Dana Sweater Industries Ltd (New)

Holding No-97, Shoildubi, Kashimpur, Gazipur.

18 December 2023

Observation-6: Falling hazard at 1st floor (Production Building-1).

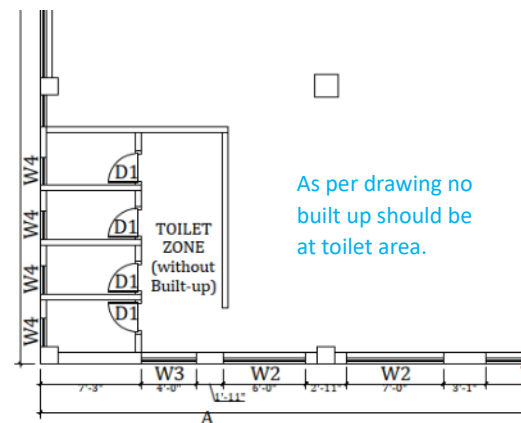
Description: Parapet/railing was not found on the 1st floor. The building engineer is required to provide edge protection to avoid falling hazard.
